REVISION TRANSMITTAL

This sheet transmits Revision 2 to SB 34-4171, which:

NAVIGATION - PROLINE FUSION UPGRADE TO PHASE 3 SOFTWARE

Figure 12. Modification of the 434-364074-0001 or 4340364074-0005 Panel Assemblies (Sheet 1)

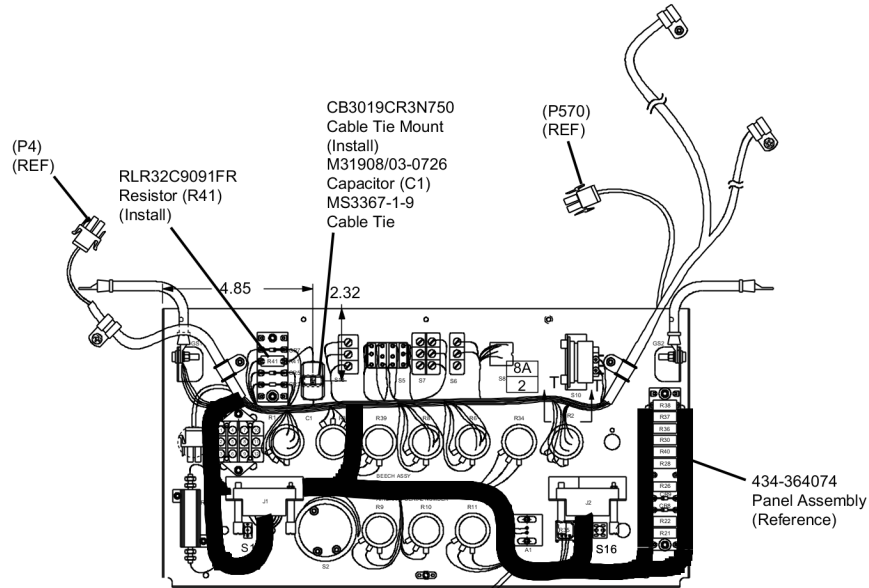
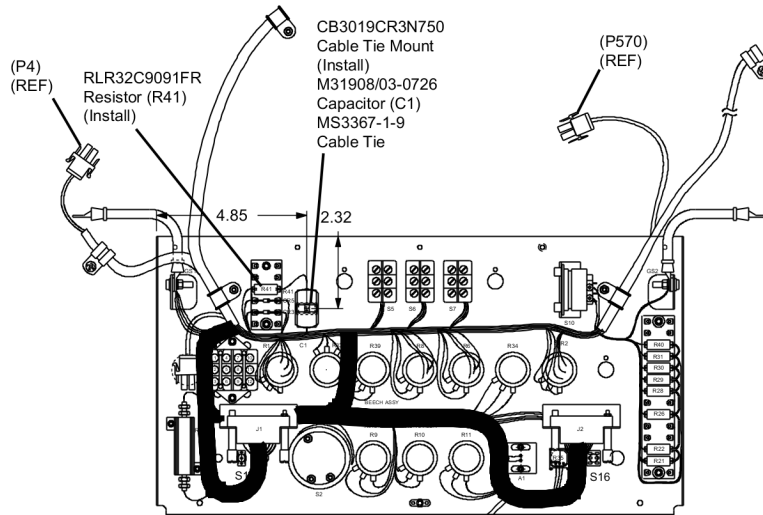
- H. Remove the overhead instrument and control panel assembly from the aircraft.
- I. (Refer to Figure 12, Details A and B.) Do the modification of the 434-364074-0001 or 434-364074-0005 Panel assemblies as follows:

- (c) With an indelible marker and tag, identify the S10-NC-J2-V-20 electrical wire as S10-NC-R41-2-20.
 - (d) (Refer to Figure 12, Details A and B.) Install one RLR32C9091FR Resistor (R41) on the 434-364074-XXXX Panel Assembly. (Refer to the King Air Standard Practices Manual, Chapter 20, - Airframe.)

Figure 13. Electrical Modification of the 434-36074-XXX Panel Assembly (Sheet 1)

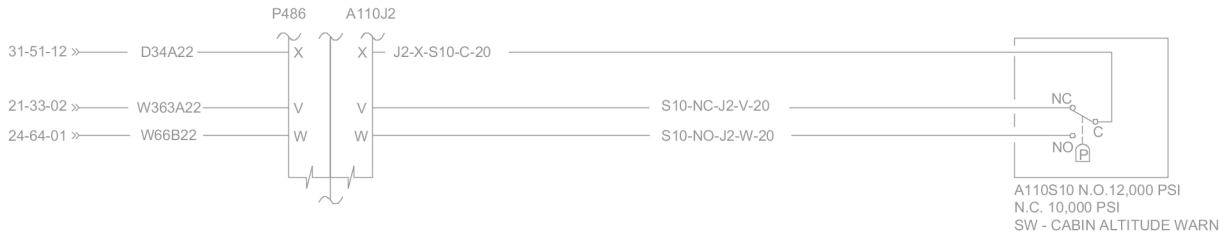
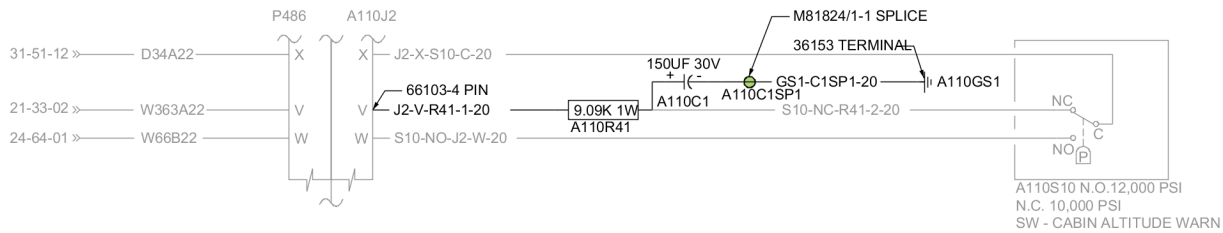
- (i) After the adhesive cures, remove the fixture from the mount with pliers.
- (2) (Refer to Figure 13, Sheet 1.) Do the electrical modification of the 434-364074-XXXX Panel Assembly as follows:

- (a) If necessary, disassemble electrical connector A110J2 on the 434-364074-XXXX Panel Assembly.
 - (b) Remove electrical wire S10-NC-J2-V-20 from electrical connector A110J2 pin "V".

Figure 14. Installation of the 101S-R41 and 101S-C1 Placards (Sheet 1)

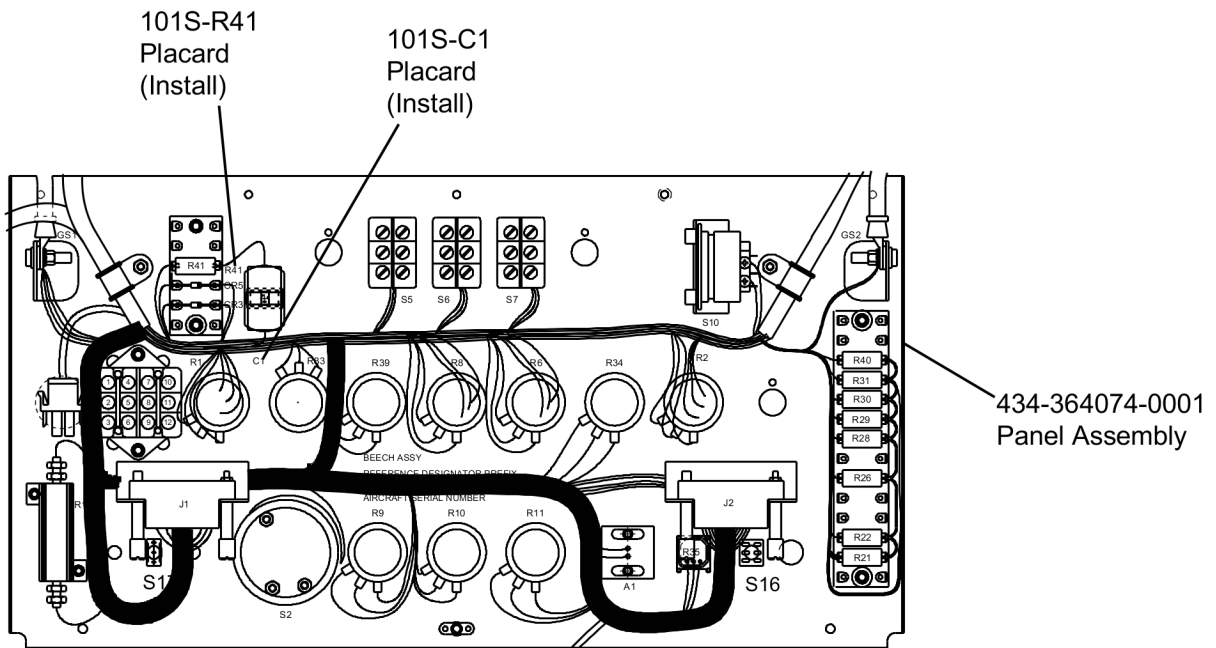
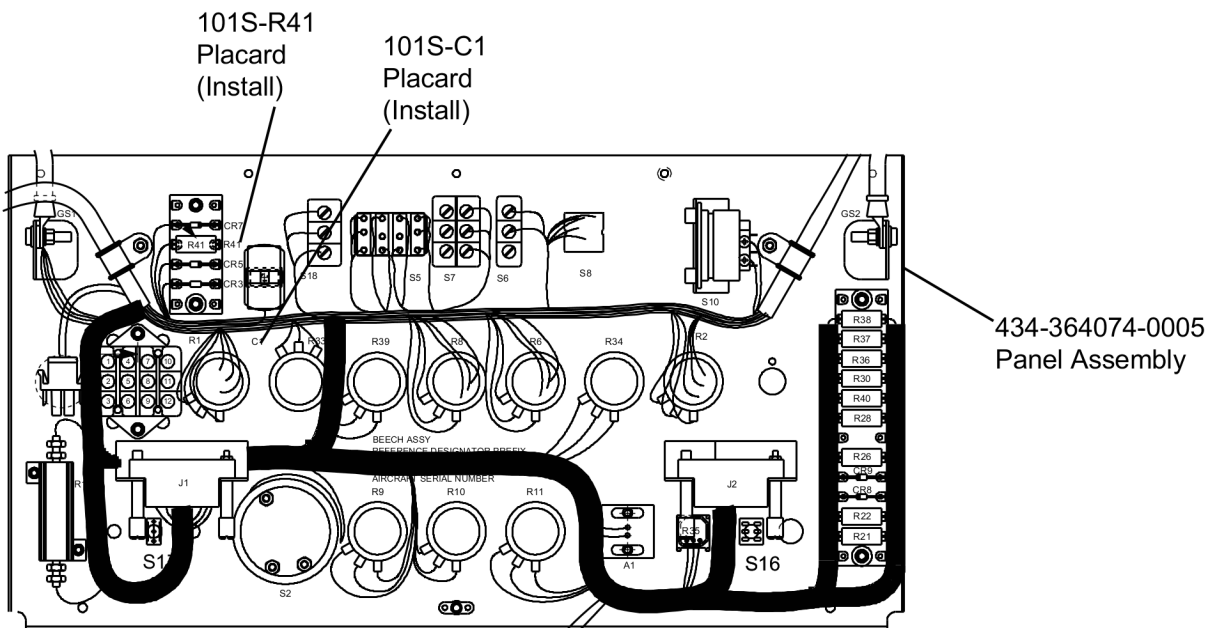
- (w) (Refer to Figure 14, Detail A.) On aircraft that modified the 434-364074-0001 Panel Assembly, do the steps that follow:
 - 1 Install the 101S-R41 decal/placard on top of the existing "CR6" decal/placard.
NOTE: It is permissible to apply adhesive over the decal/placard to help attach it to the surface of the panel assembly

- 3 Go to Step J.
- (x) (Refer to Figure 14, Detail B.) On aircraft that modified the 434-364074-0005 Panel Assembly, do the steps that follow:
 - 1 Install the 101S-R41 decal/placard above the "CR5" decal/placard.
NOTE: It is permissible to apply adhesive over the decal/placard to help attach it to the surface of the panel assembly

Figure 15. Modification of the Cabin Altitude Warning electrical wiring (Sheet 1)

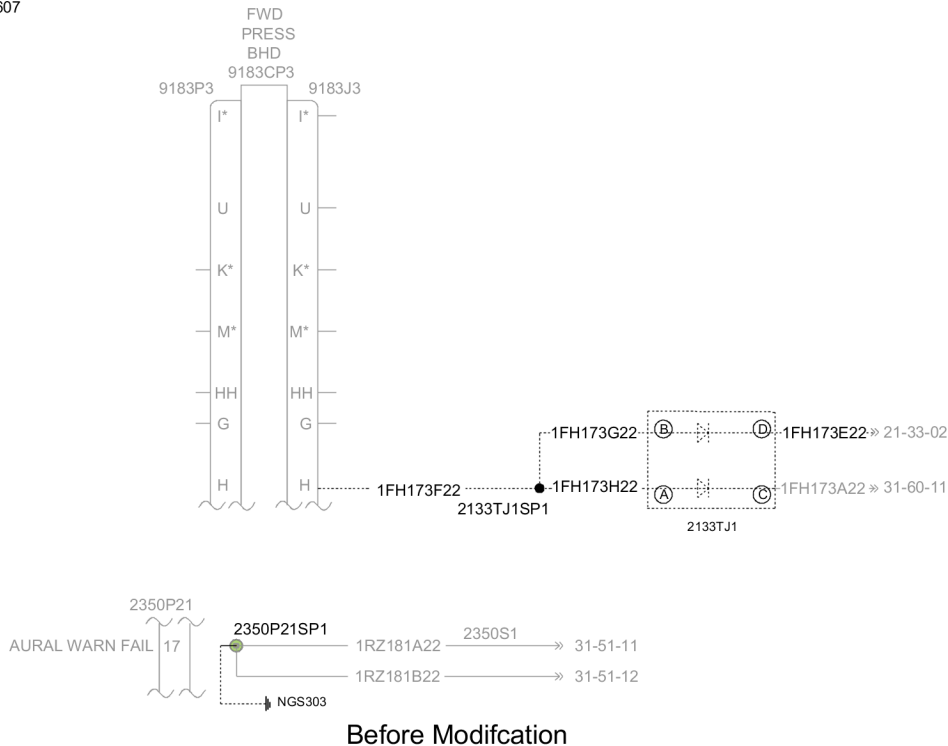
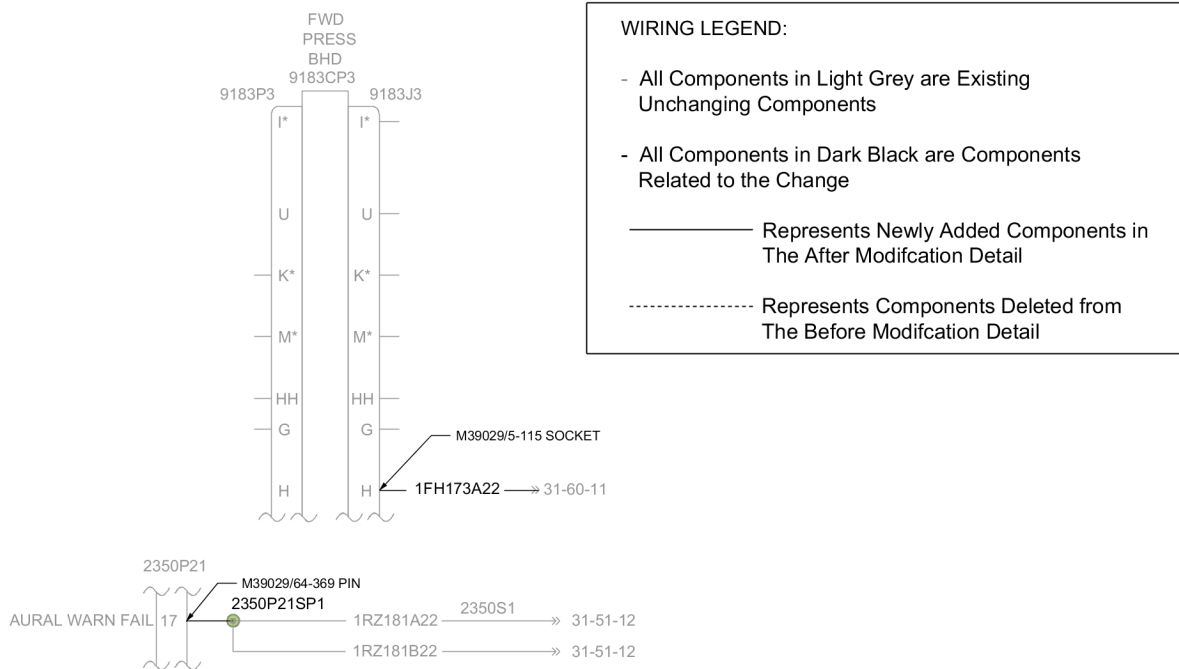
- J. Install the overhead instrument and control panel assembly on the aircraft.
- K. (Refer to Figure 15, Sheet 1.) Do the modification of the cabin altitude warning electrical wiring as follows:

- (1) If necessary, disassemble electrical connector 9183J3 at the forward pressure bulkhead of the aircraft.
 - (2) Remove electrical wire 1FH173A22 from pin "C" of 2133TJ1 Terminal Junction.

- (3) Cut and remove the terminal from electrical wire 1FH173A22 and install one M39029/5-115 Socket.
 - (4) Install electrical wire 1FH173A22 into electrical connector 9183J3 pin "H".

Figure 16. Modification of the B300/B300C Aircraft Lighting System Electrical Wires (Sheet 1)

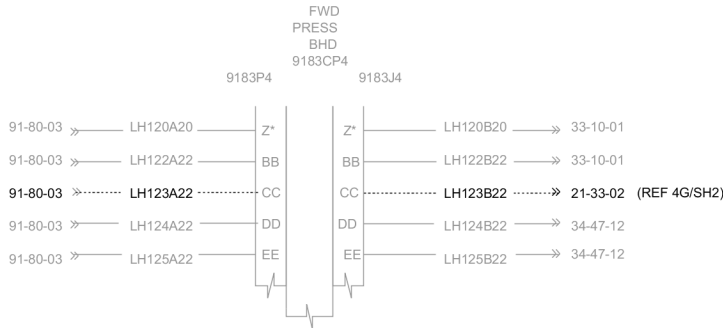
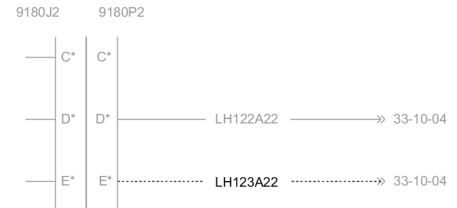
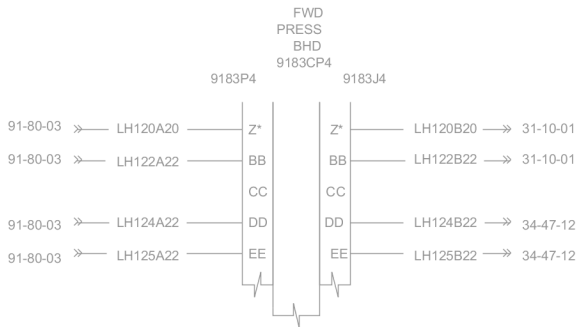
- L. (Refer to Figure 16, Details A and B.) Do the modification of the aircraft lighting electrical wiring as follows:
- (1) Disconnect electrical connector 9180P2 from the nose junction box assembly.

- (4) Remove electrical wire LH123A22 from pin "CC" of electrical connector 9183P4.
 - (5) Remove electrical wire LH123B22 from pin "CC" of electrical connector 9183J4.

- (6) Remove electrical wire LH123A22 from pin "e" of electrical connector 9180P2.
 - (7) Remove electrical wire LH123A22 and LH123B22 from the aircraft.
NOTE: Electrical wire LH123B22 was disconnected from electrical connector 9183P22 pin "10" in Step 10.D(12).

Figure 17. Modification of the No. 1 and No. 2 Remote Data Concentrator RDC-4002 electrical wiring (Sheet 1)

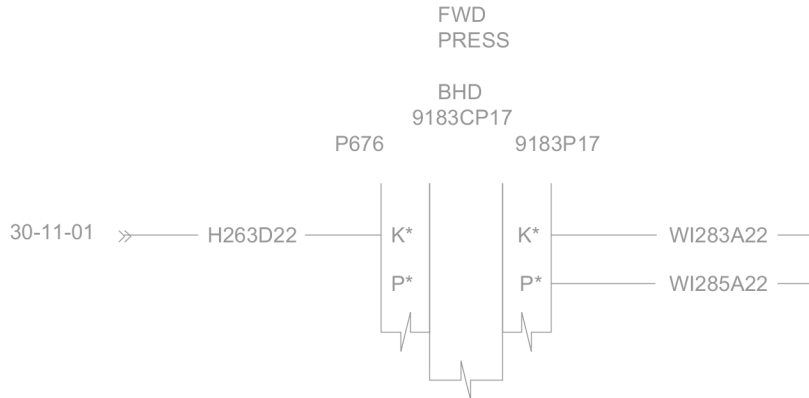
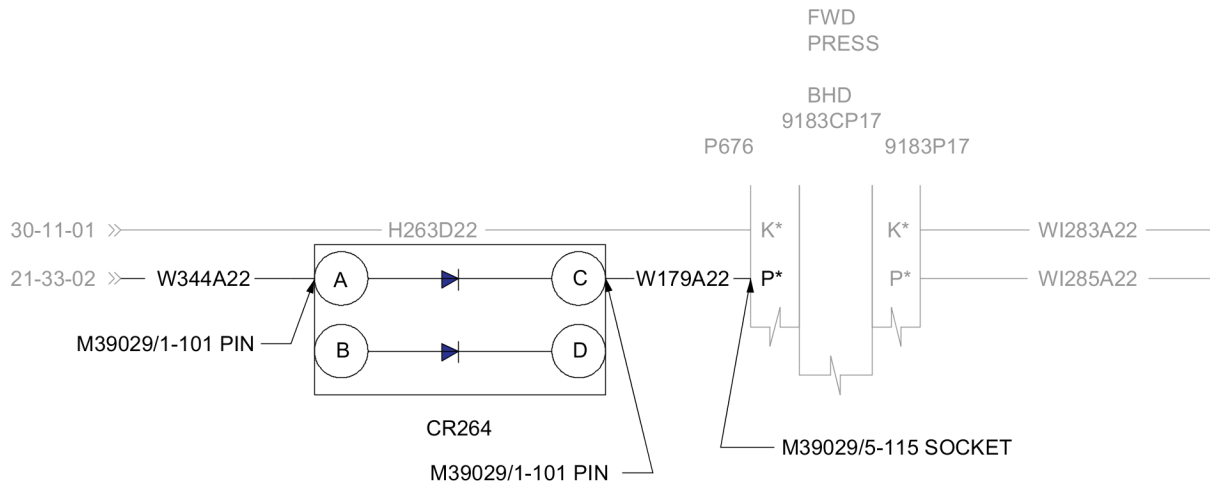
- O. Do the modification of the No. 1 and No. 2 Remote Data Concentrator RDC-4002 electrical wiring as follows:
- (1) (See Figure 17, Sheet 1.) Disconnect electrical connector P676 from the forward pressure bulkhead.

Figure 18. Modification of the No. 1 and No. 2 Remote Data Concentrator RDC-4002 electrical wiring (Sheet 1)

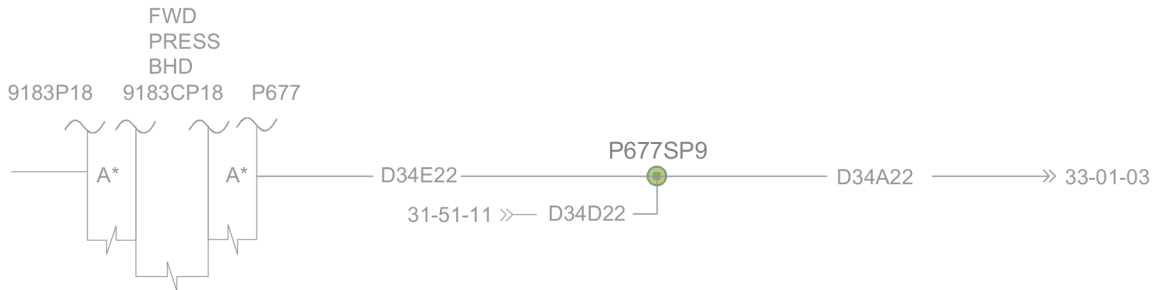
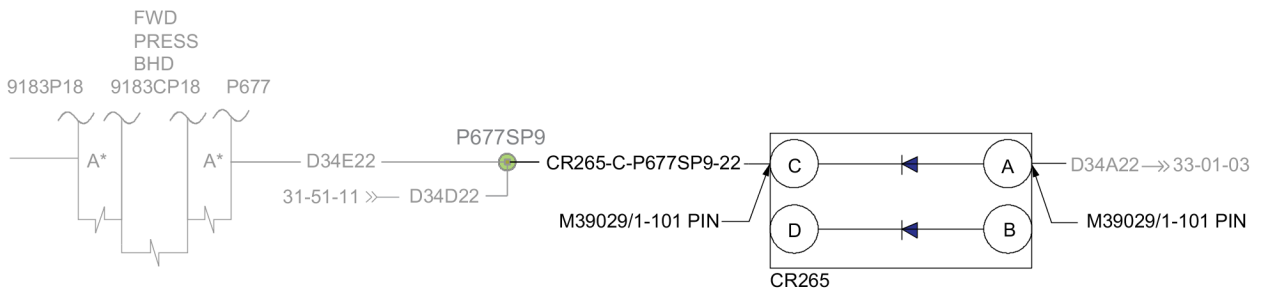
- (8) (Refer to Figure 18, Sheet 1.) Locate electrical connector P677 on the forward pressure bulkhead.
 - (9) Cut electrical wire D34A22 a minimum of 11.0 inches from the P677SP9 Splice.

Figure 19. Removal/Installation of the Pro Line Fusion Placards (Sheet 1)

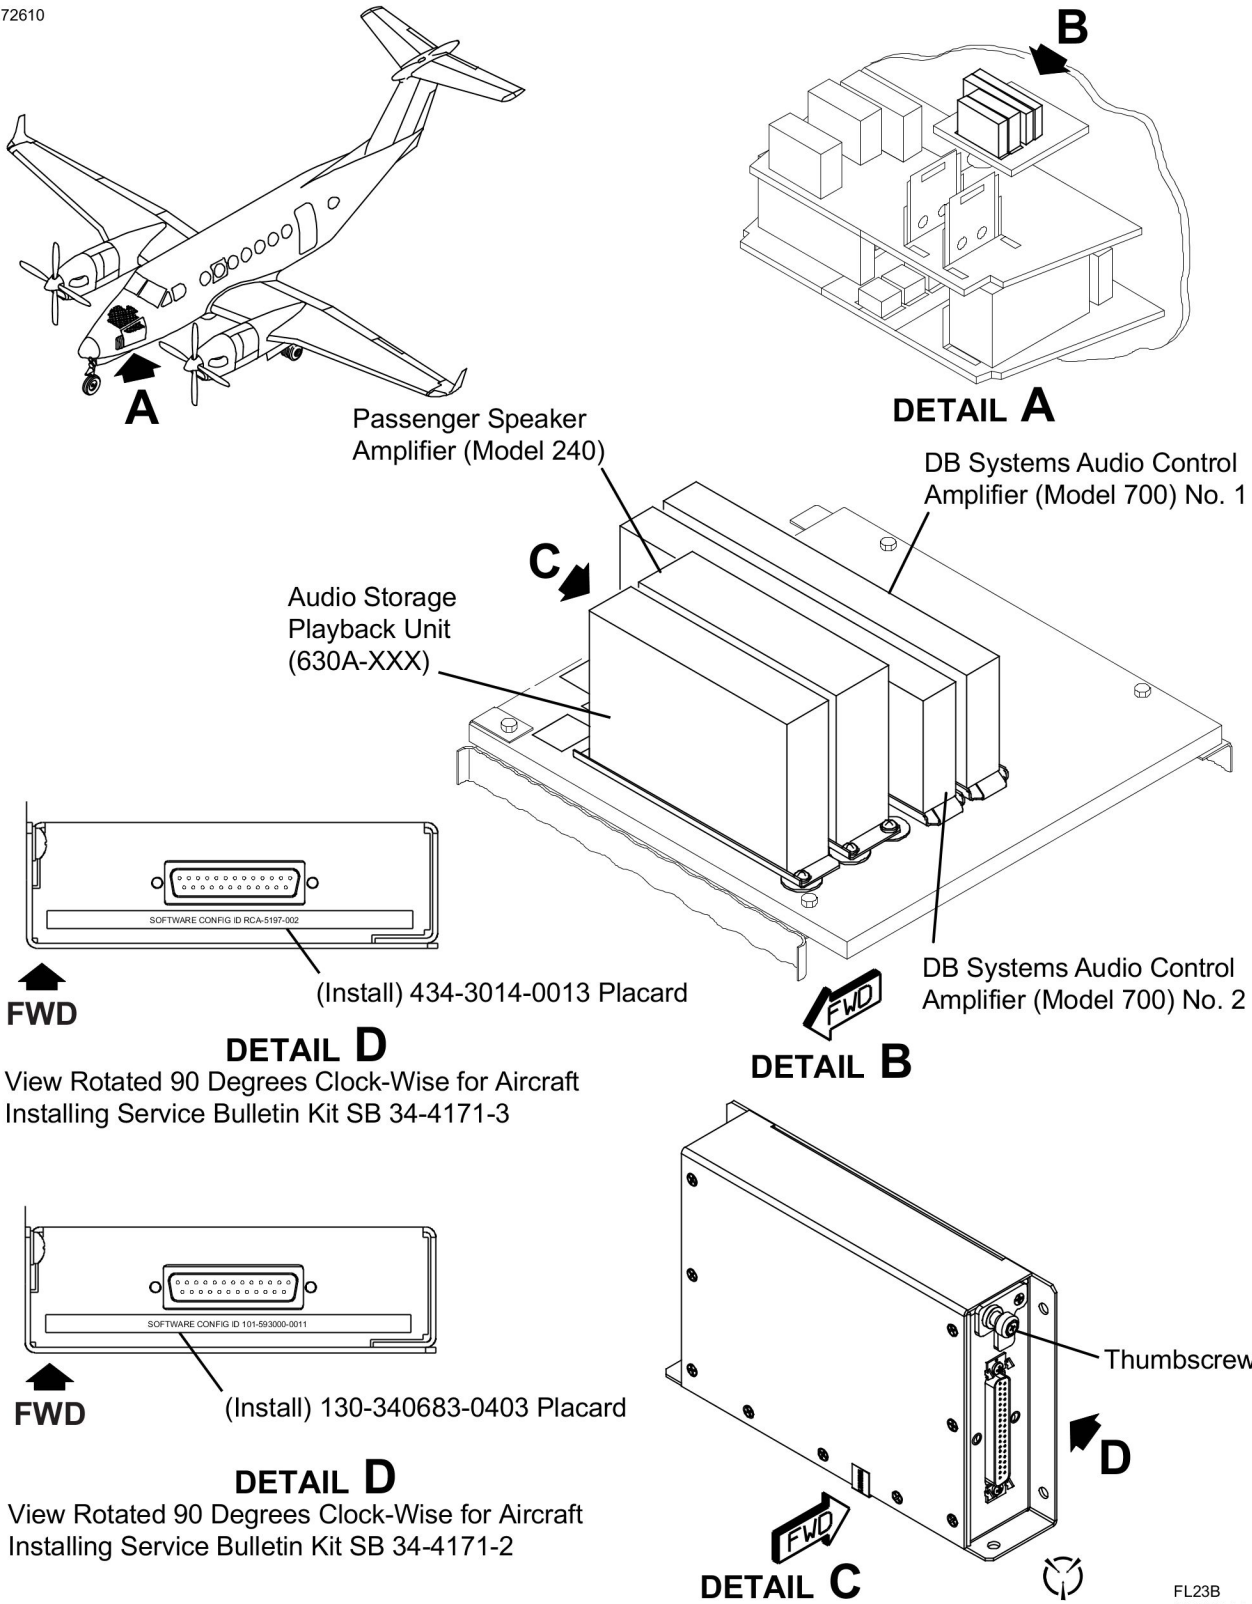
- (c) Go to Step O.
 - (16) (Refer to Figure 19, Detail D.) On Beechcraft Model B300/B300C that installed Service Bulletin kit SB34-4171-3, do the steps that follow:

Figure 21. Modification of the SMS alert Wiring (Sheet 1)

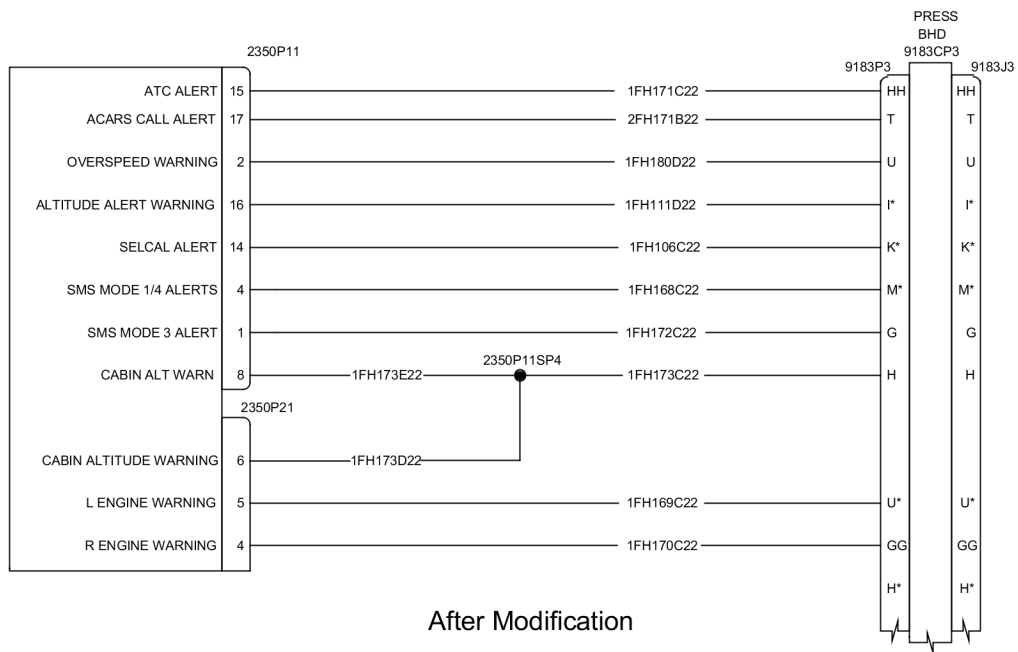
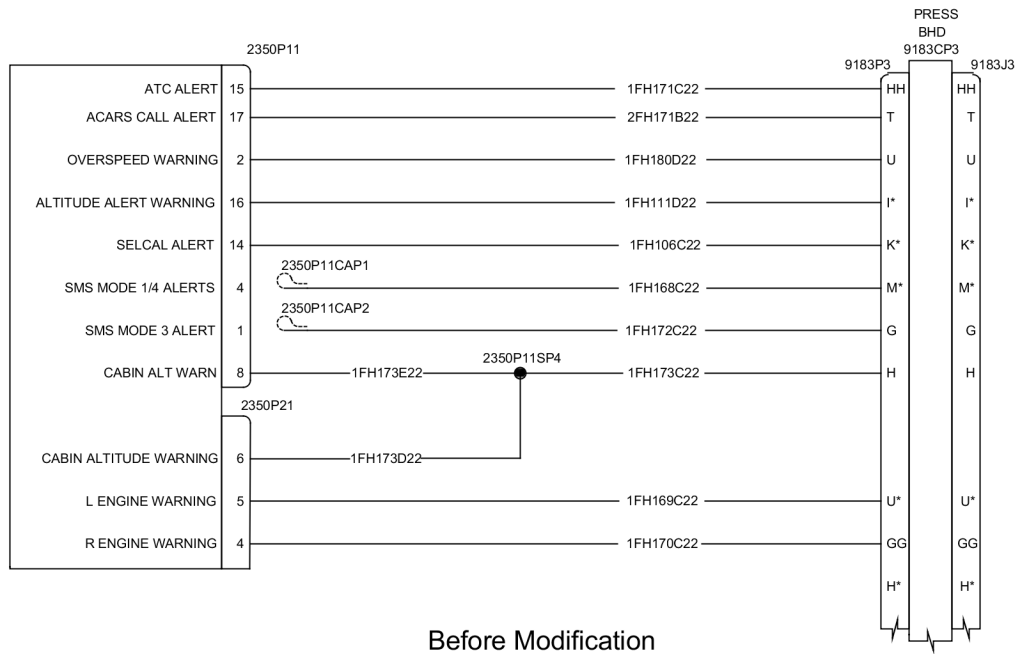
- J. Adds Figure 21 and Step 13.I to modify the SMS alert wiring.
- K. Makes other minor editorial changes throughout the document.

- I. (Refer to Figure 21, Sheet 1.) Do the modification of the SMS alert wiring as follows:
- (1) Locate capped and stowed electrical wires 1FH168C22 and 1FH172C22.
